# CITY OF ALBUQUERQUE

**RE: Murphy Express – Wyoming  
1358 Wyoming Blvd  
Temporary C.O. - Accepted  
Engineer's Certification Dated 07/01/19  
Engineer's Stamp Date: 01/12/18  
Hydrology File: J20D037**

Based on the Certification received 07/02/2019 and site visit on 07/03/19, this certification is approved in support of Temporary Release of Occupancy by Hydrology. The following comment needs to be addressed prior to acceptance for Permanent C.O. of the above referenced project:

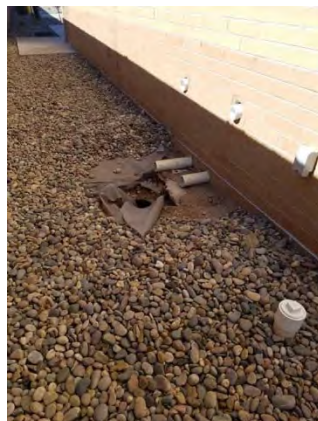
1. Please install the drain cover and finish the landscape rocks at the rear of the building.

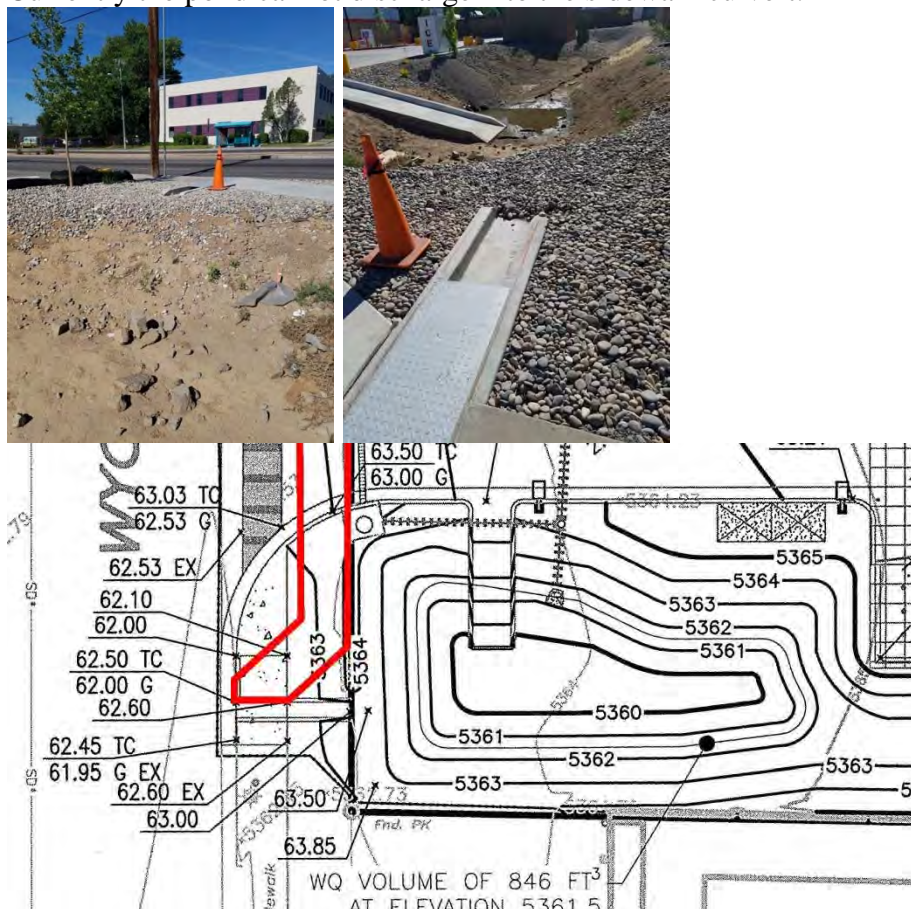
- Please finish installing the landscape rocks within the pond to stop erosion which is currently evident from the recent rainfall.

- The pond also needs to be reshaped at the outfall sidewalk culvert per the approved plans. Currently the pond cannot discharge into the sidewalk culvert.
